SUBJECT : Waterbags for old DG-100's with dump valve
in the fuselage

EFFECTIVITY : DG-100 and DG-100G Ser.No. 1 - 103
(not DG-100 ELAN)

Tag	Name	Glaser-Dirks Flugzeugbau GmbH 7520 Bruchsal 4 Im Schollengarten 19-20
					Gez.	25.7.78 / Baldner	
					Gepr.		
					Norm.		
					Maßstab	1:1	
					Maße ohne Toleranz- ang. nach:		ANSCHLUSSSTÜCK F. F 16 DG 100 (Vers. Ablauf. i. Rumpf)
					Ausg. Änderung Amt Tag Name		DG F 17

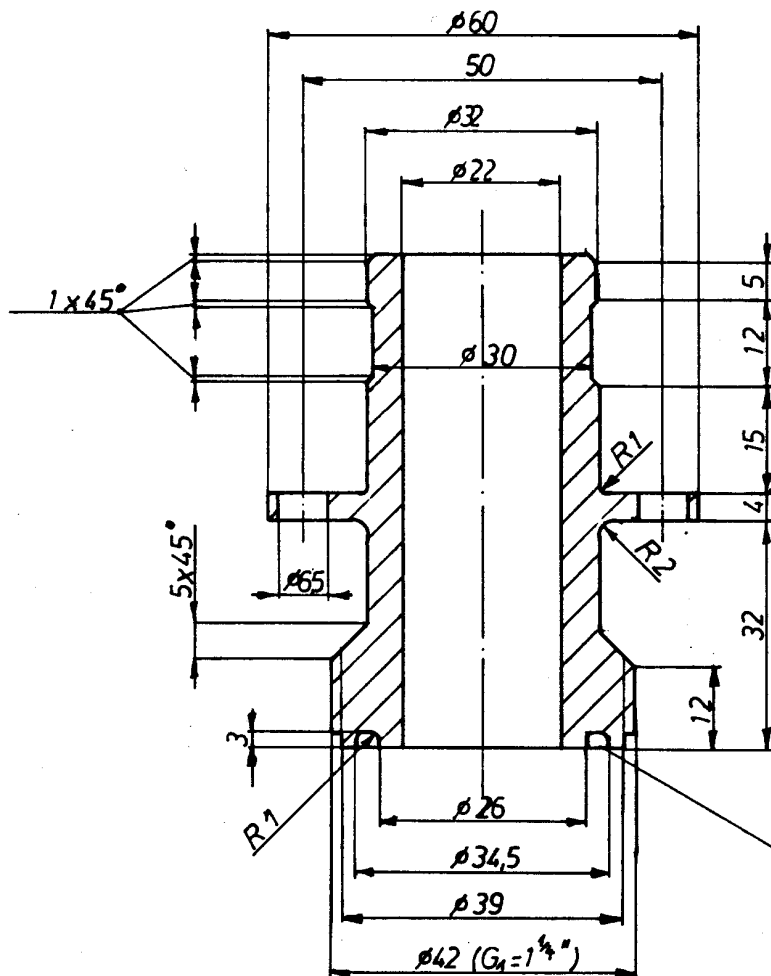
INSTRUCTIONS : Modification according to drawing F18
Connect the new waterbag F16 (nylon fabric
reinforced) with connector F17. The GFRP
plate fixed to the old bag in the wingroot-
rib must be used again.

für O-Ring $d=25$
 ($\phi_1=28,2$ $\phi_2=35,2$ $b=3,5$)
